ARKANSAS STATE HIGHWAY & TRANSPORTATION DEPARTMENT
EQUIPMENT AND PROCUREMENT OFFICE
LITTLE ROCK, ARKANSAS

NOTICE TO BIDDERS
ADDENDUM

Bid No. M-17-028P

District 3 Headquarters Administration Office Renovations

FOUNDATION PLAN SCALE 1/8"=1'-0"
 ADMINISTRATION & MAINTENANCE BUILDING

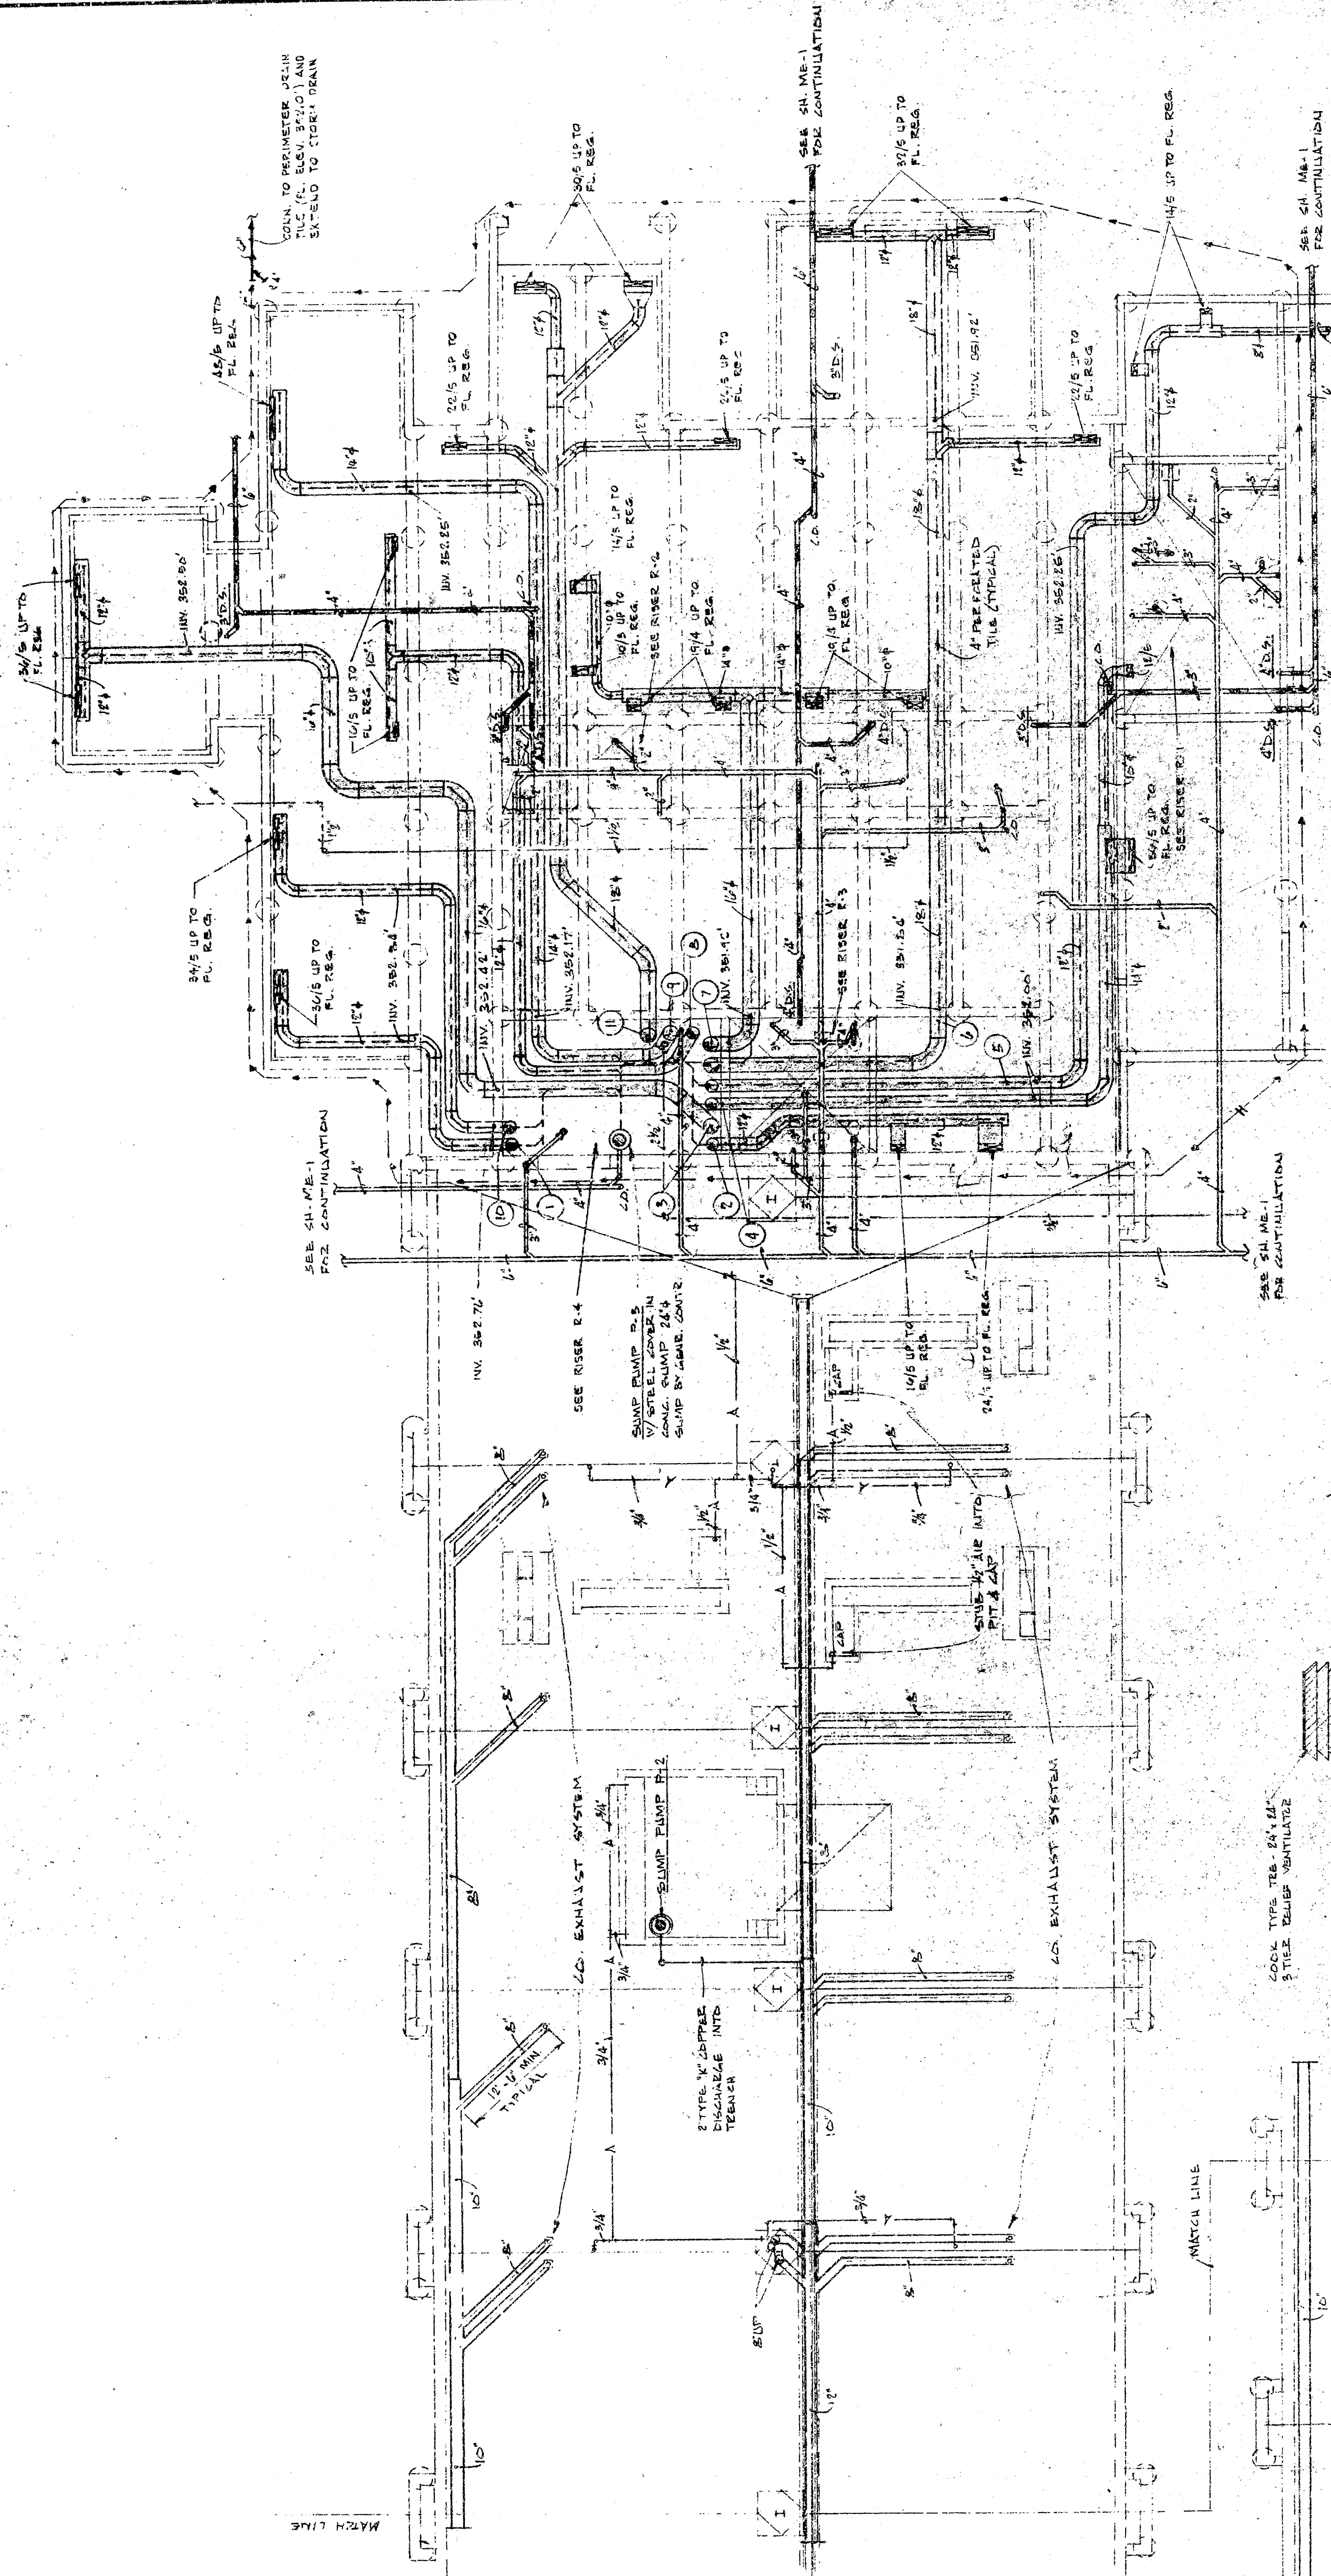
Contractors may use the attached plans to estimate flowable fill quantity in ductwork beneath slab.
